# 1600 DEXTER

DESIGN RECOMMENDATION  
MARCH 1, 2017  
DPD #3021980

MASSING ARTICULATION STUDY FROM EDG

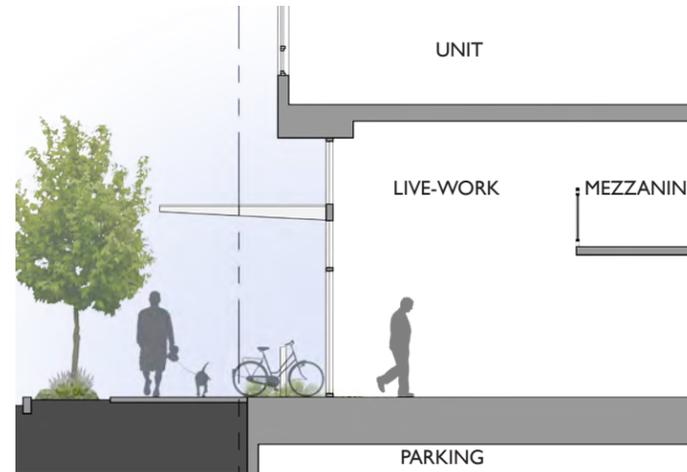
The Board was generally supportive of the preferred massing option as it successfully breaks up the volume of the building structure. However, the Board was concerned about how the courtyard would be activated and not be relegated to an empty space. While the size of the courtyard is appealing, the Board was concerned that there are not enough entry points into the courtyard and wanted to see this space further developed and programmed to be activated. Board members also supported the terracing approach of the building layout and the stepping down the slope to the alley. (CS2-D, DC2-A, DC2-B, DC2-D, DC2-E)

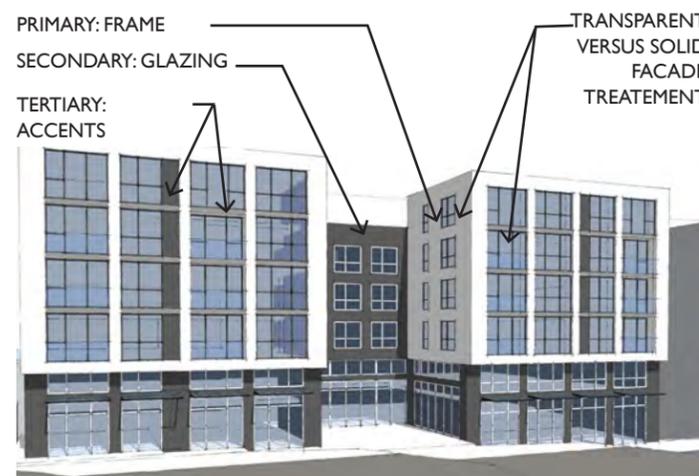
The Board was generally supportive of the conceptual architectural expression along Dexter and the live/work unit approach. However, they argued that the units need to be as porous as possible to activate the street along Dexter and engage the courtyard as much as possible. The Board debated the pros and cons of making the unit closest to the courtyard for a true commercial use or as a live/work as a strategy for keeping that edge along the courtyard as porous as possible. The Board was concerned that if the space were used as live/work solely then the courtyard facing facade would need to be kept open and porous. Whichever use the space becomes, the Board wanted to make sure that the space aids in the activation of the courtyard, regardless of its function. Finally, the Board was in support of the level of vegetative planting proposed in the preferred option along with the response to the bike lane along Dexter and the use of a 'hitching post' bike rack. (PL1-B, PL2-C)

#### » Response:

As described previously, the space directly north of the courtyard has been revised to be commercial space with a stoop to provide porosity and connection to the courtyard. Bicycle hitching posts have been kept along the streetscape with several more added adjacent to the south commercial space. The streetscape has been further developed with additional street furniture, low planter walls to maintain sightlines into the courtyard, and glass canopies for overhead weather protection.

REVISED BIKE PARKING LOCATION ON P1

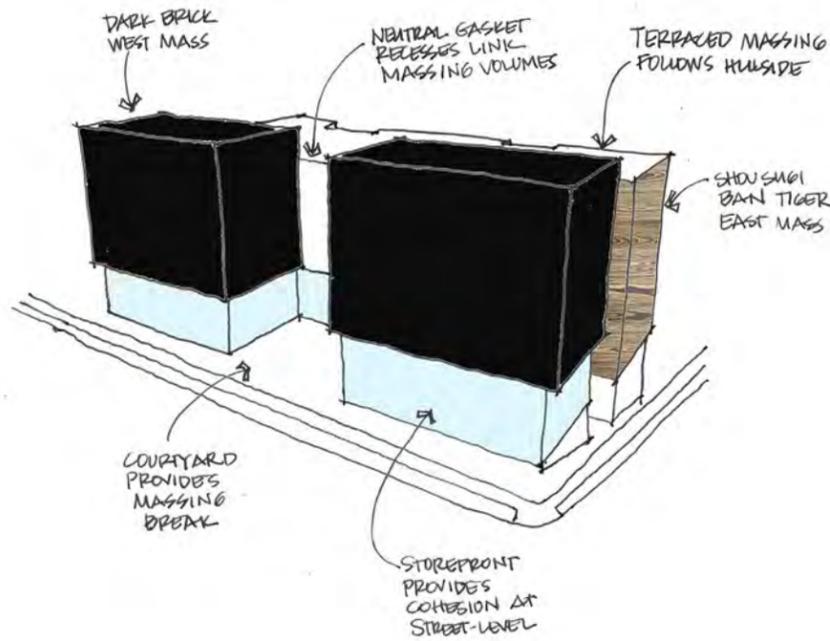
The Board wanted to see the bike access located closer to the alley with the bike storage room closer to the garage. (PL4-B, DC1-A, DC1-C)

### » Response:

The proposed design has placed the bike storage room on Level P1 adjacent to the alley. The bike storage is directly adjacent to a building entry and is in close proximity to the elevator core. This location maintains building security and ease of use for bicyclists.
